REQUEST FOR INFORMATION

Project Name: York Region Admin., Package D Renovation

CONSULTANTS RFI NO: TC24-114-15-X

Ground Floor Block D Duct Sizing

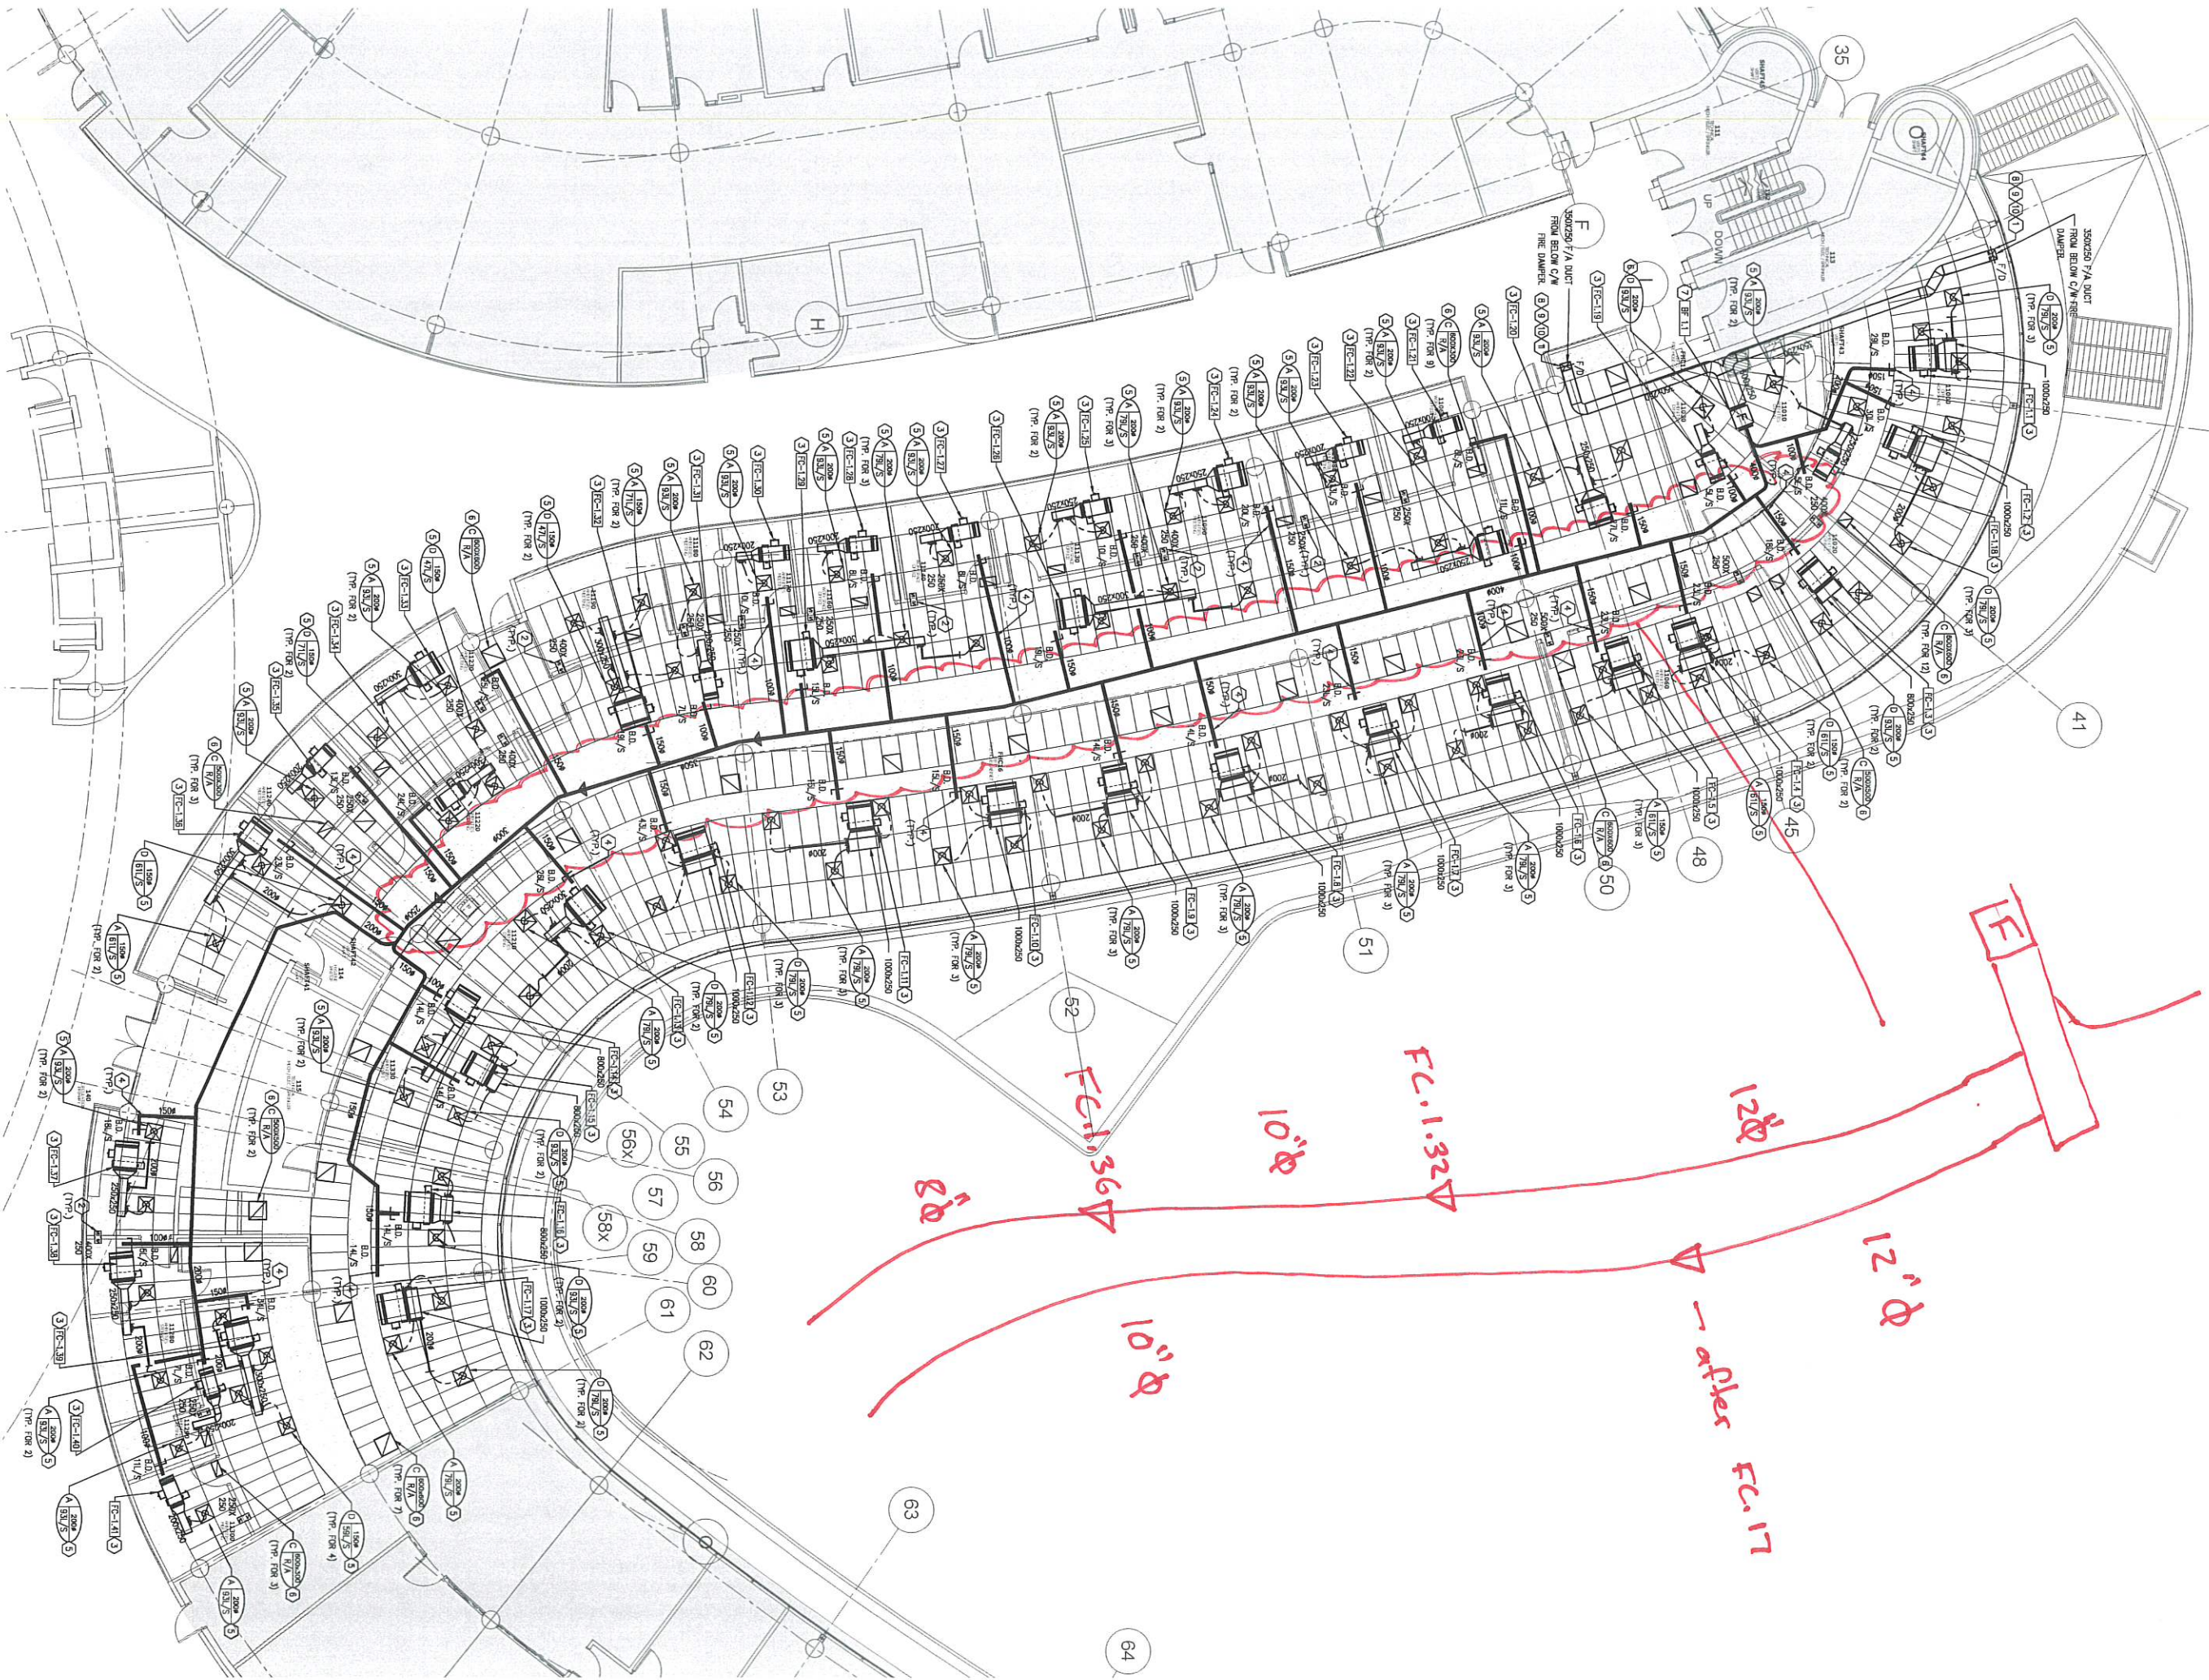
16" round will not fit due to site conditions and height restrictions
See attached Drawing

GPY Response: The proposed two main runs of fresh air duct are acceptable. Contractor to ensure ducts are sized to deliver the required fresh air noted on the drawings. Contractor to ensure all changes/ revisions that deviates from the IFC set shall be reflected on the As-built drawings.
